9.2 NO. 188 (LOT: 1; D/P: 33790) VINCENT STREET, NORTH PERTH - PROPOSED ALTERATIONS AND ADDITIONS TO PLACE OF WORSHIP

RECOMMENDATION:

To consider an application for development approval for alterations and additions to the Redemptorist Monastery and Church at No. 188 Vincent Street, North Perth (the subject site).

MEZZANINE
FLOOR PLAN
SCALE: 1:100

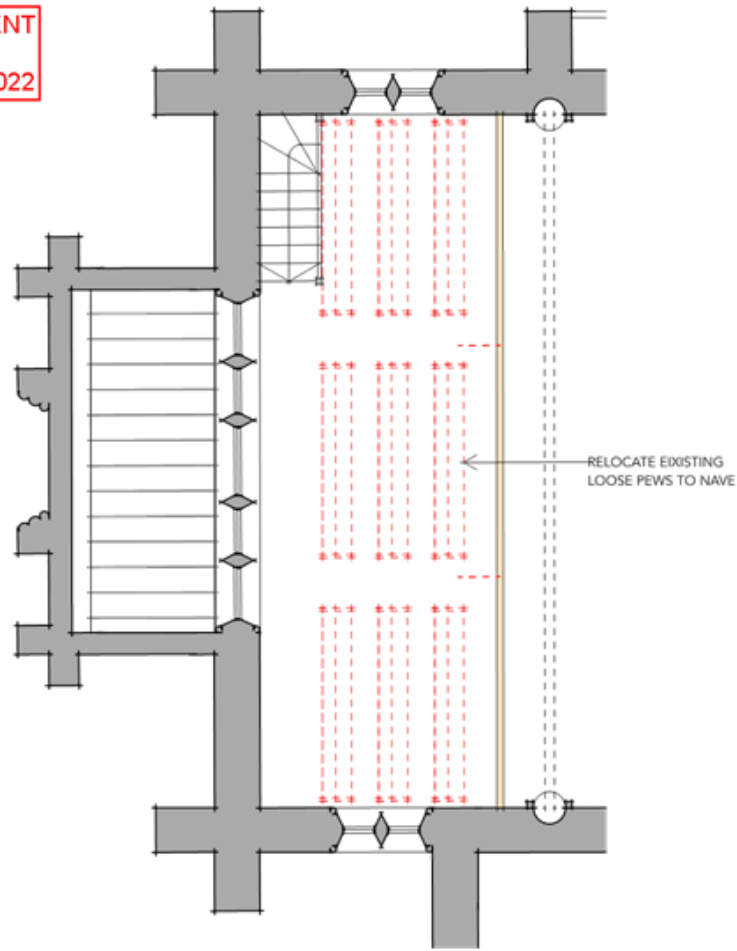
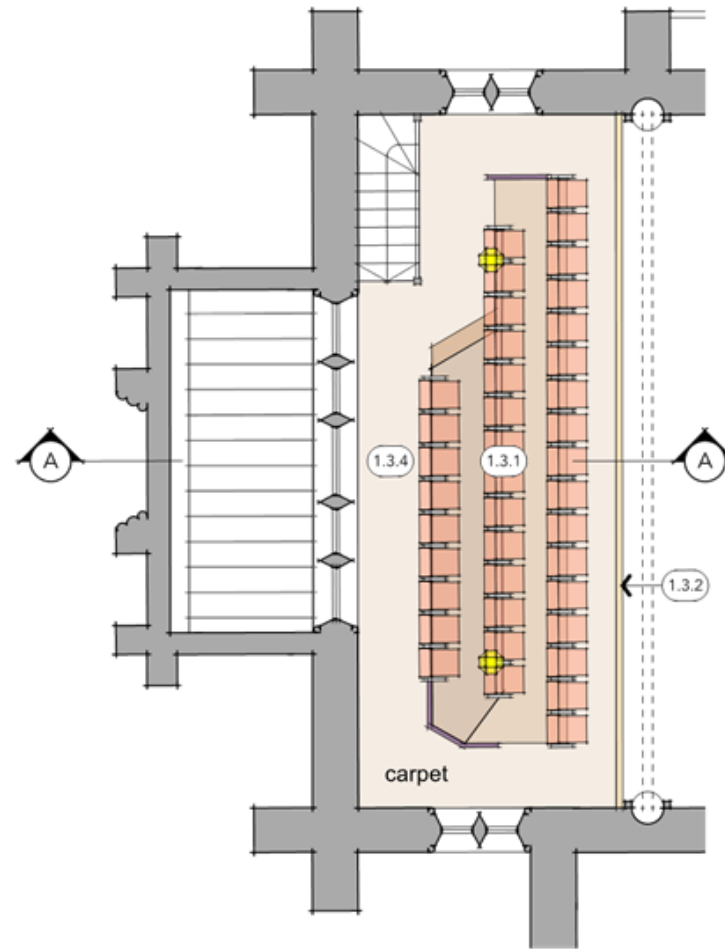
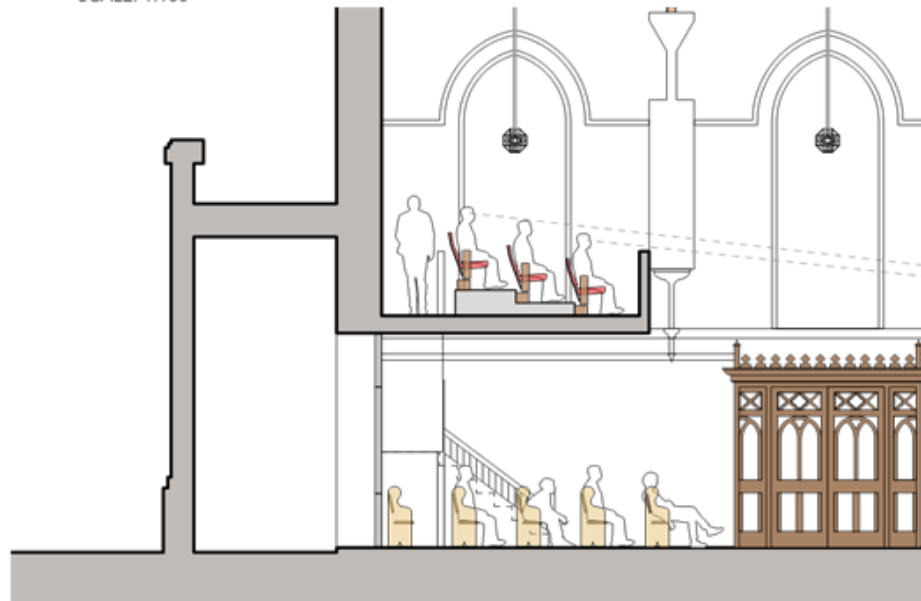
- Choir Gallery: The Choir Gallery is noted in the Conservation Plan as being in a fair – poor condition. The proposed works would improve the usability of the space by introducing a rake to the seating. Existing pews within the Choir Gallery would be retained and relocated on-site. The introduction of improved seating would contribute to the ongoing use of the Church for religious worship;

NARTHEX
WESTERN ENTRANCE PLAN
SCALE: 1:100

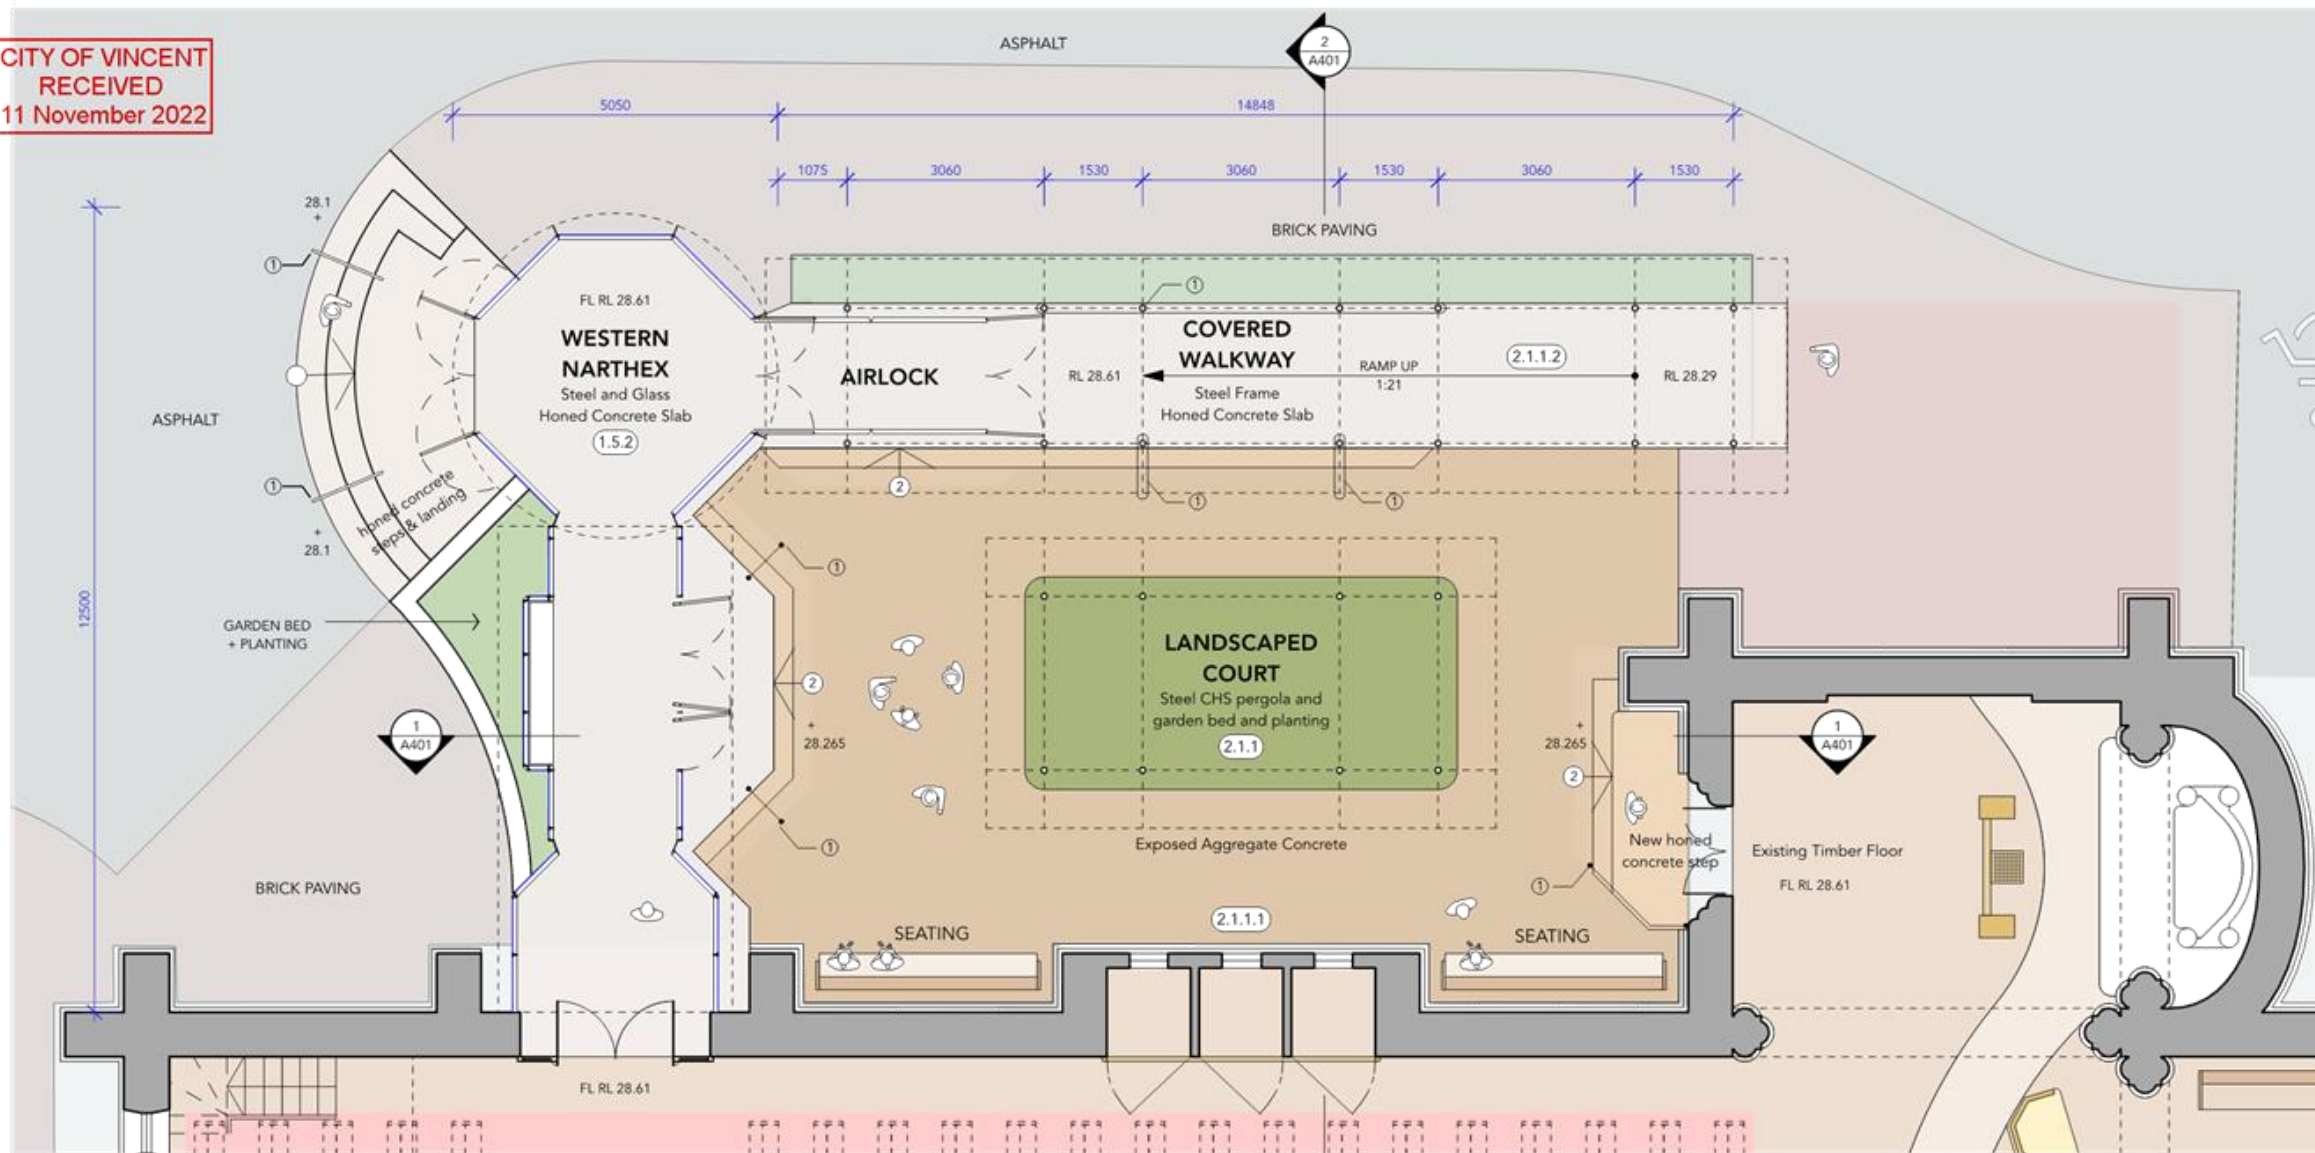
3.2 The glazing to the covered walkway and Narthex shall provide a minimum of 70 percent visible light transmission to provide unobscured visibility;

- The proposed Narthex would be clearly identifiable as new work. It is a lightweight independent structure that would not impose on the Church. The copper domed roof would be in-keeping with transepts and is contemporary in design. The Narthex is designed in a manner that is sympathetic to the Church building and would not have a negative impact on the heritage values of Redemptorist Monastery and Church;

- The removal of the confessionals and constructing a new western entrance would be sympathetic to the heritage fabric of the place and assist Church access. While views of the western façade would be impacted, this is considered acceptable due to the improved access benefits;
- The form and materiality of the Narthex would be sympathetic to the aesthetic heritage values of the Church. Steel, glass, and a standing seam copper roof combine to form a material palette that will be complementary to the Church materiality; and
- The open style contemporary structure will not impact on the cultural heritage values of the Church.

- Glazing to Narthex: The applicant has amended the plans to show the glazing to the Narthex and enclosed walkway to be clear laminated glass. The glass is discussed further below in the Comments section.
- Landscaping to Car Park: Following the conclusion of advertising, the applicant deleted the reconfiguration and expansion of the car park from the application. Except for the car bays removed immediately to the west of the Church to enable the construction of the proposed entry, the car park would remain as existing. As there are no car park expansion works, new trees are not proposed within the existing car parking area.

This Sheet: **GF plan - Sanctuary**

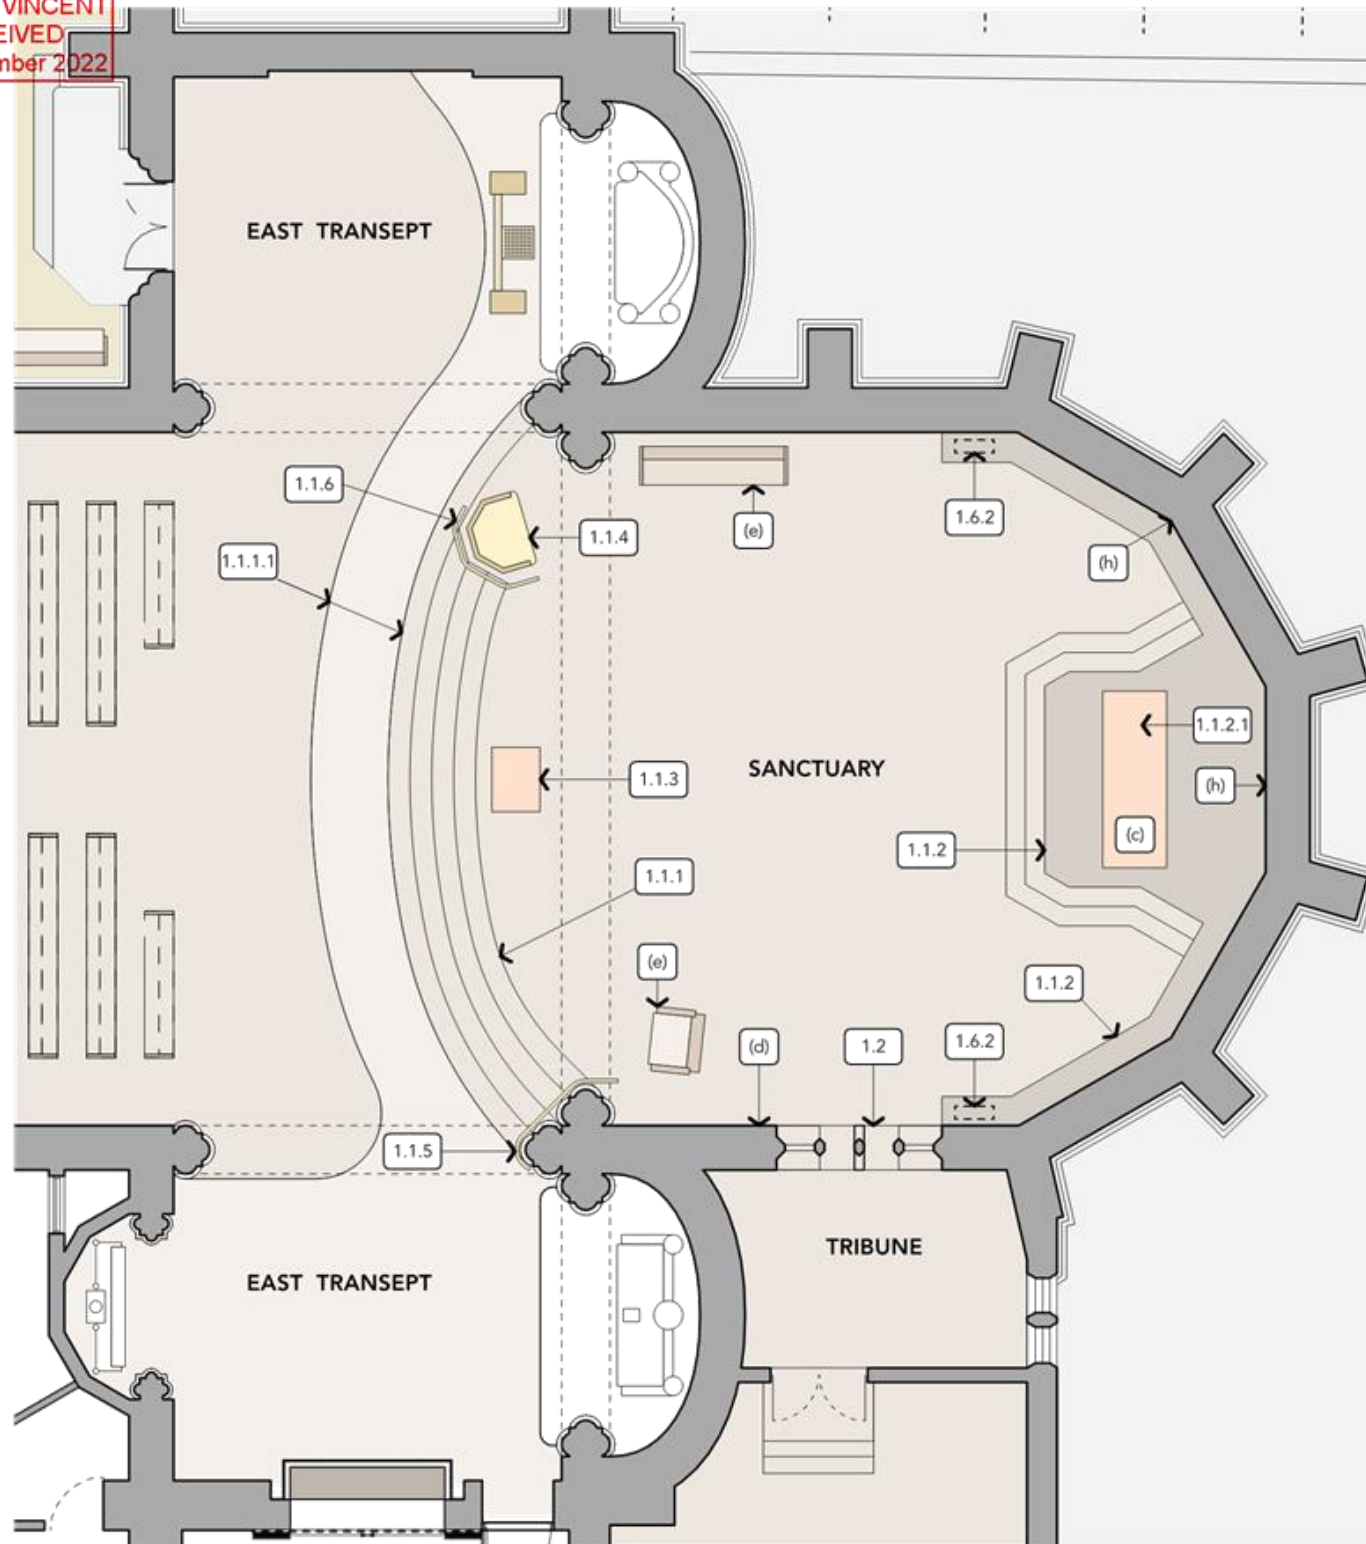
The deconstruction of the confessional and new openings to the Tribune Screen wall shall be undertaken with care. As much of the fabric as possible, including limestone should be retained for reuse, to the satisfaction of the City;

- The internal modification to extend the Sanctuary dais, modification of the Tribune screen and replacement of the seating would have minimal impact the heritage fabric of place. These works are all considered to fall within 73(3)(a) of the *Heritage Act 2018*;

- The proposed works to the Sanctuary, including expanding the dais, creating an alter podium with acolyte seating, relocation of the pulpit, and modifications to the mullions of Tribune tracery screen to enhance access are considerate of the Conservation Plan;

NO.	DATE	REVISION
Project Redemptorist Church Conservation		
Address North Perth WA		
This Sheet Western Narthax - Nave Opening		
Plot Date	11/11/22	
Scale @A2	NTS	Rev
Project No	202123	
Drawing No	DA711	
© 2022 Copyright Slavin Architects

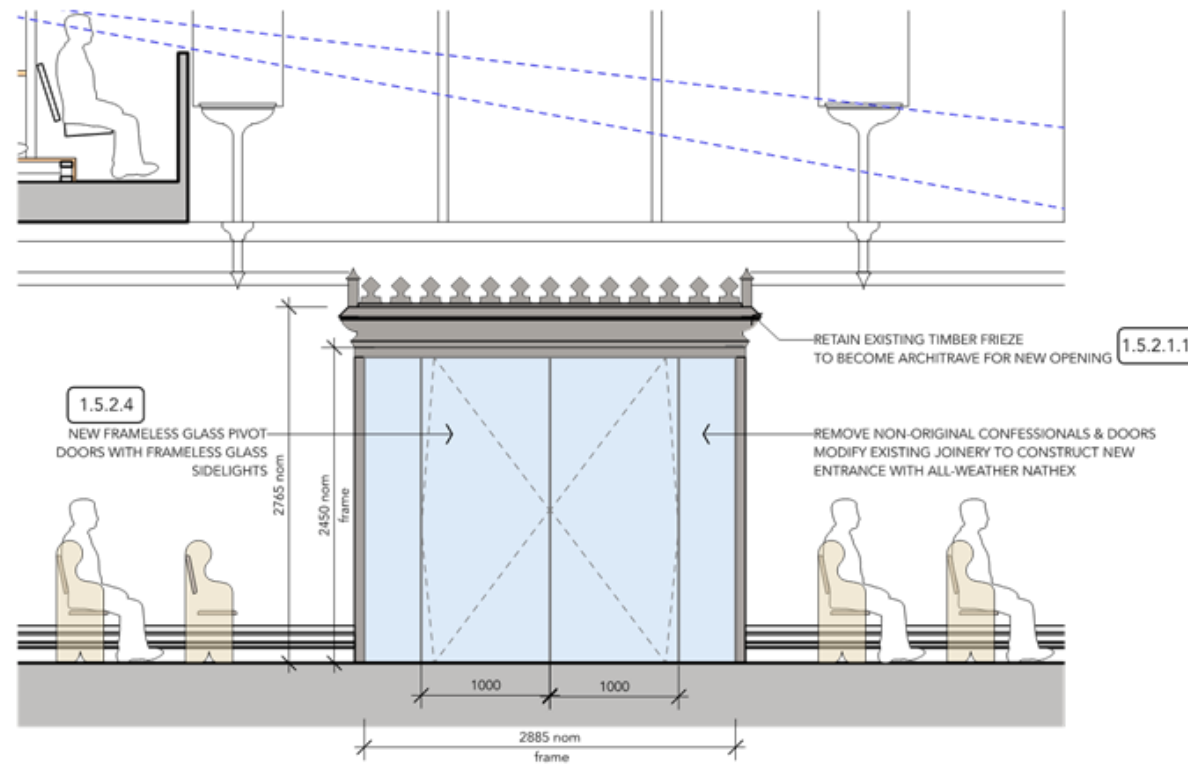
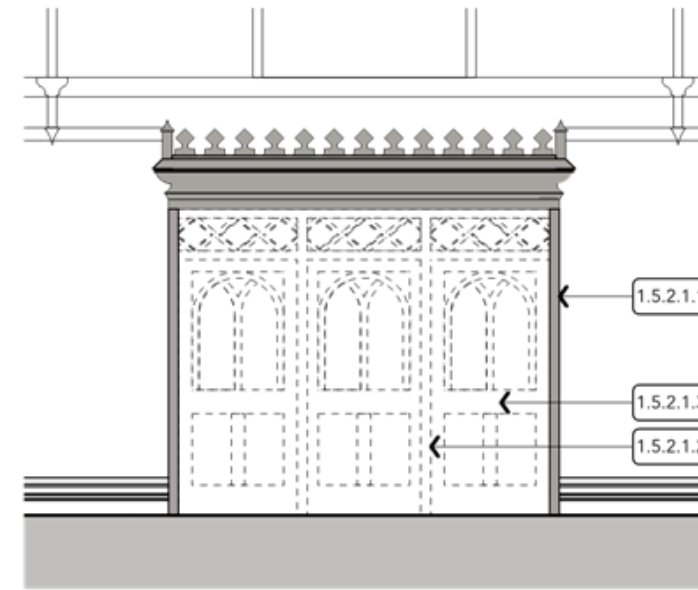
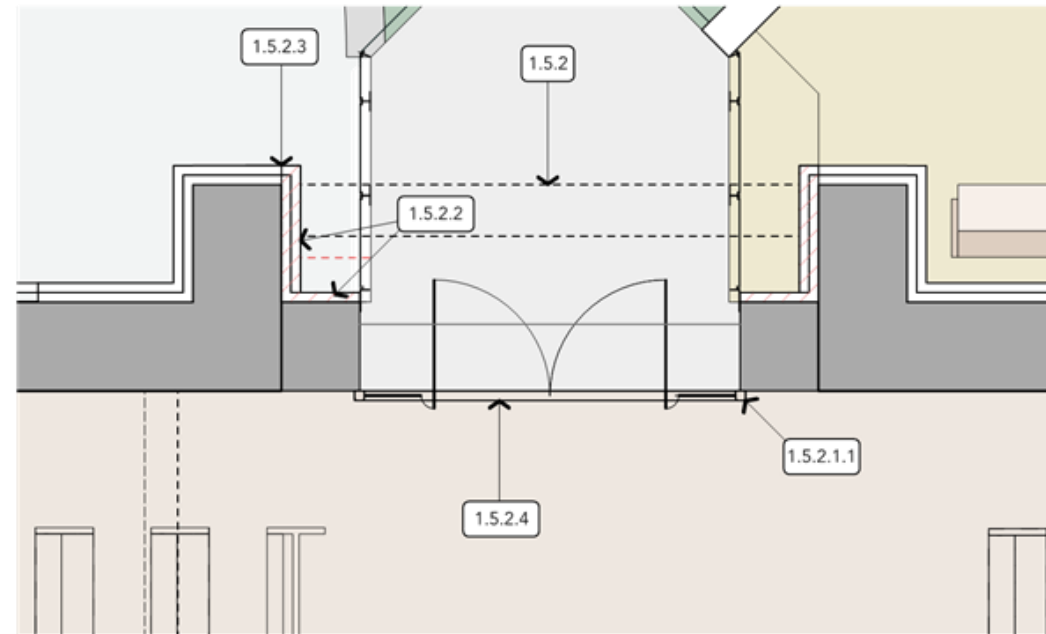
- The removal of the southern confessional on the western elevation would return that part of the building to an earlier state and would have minimal impact on the original heritage fabric of the Church;

- Demolition of the Confessionals and New Entry: The application proposes the demolition of the southern three confessionals to the western elevation which were a later addition to the original Church. The confessionals were categorised in the Conservation Plan as being of 'some' significance given their small scale and status as a later addition. The demolition of the confessionals is supported for the following reasons:
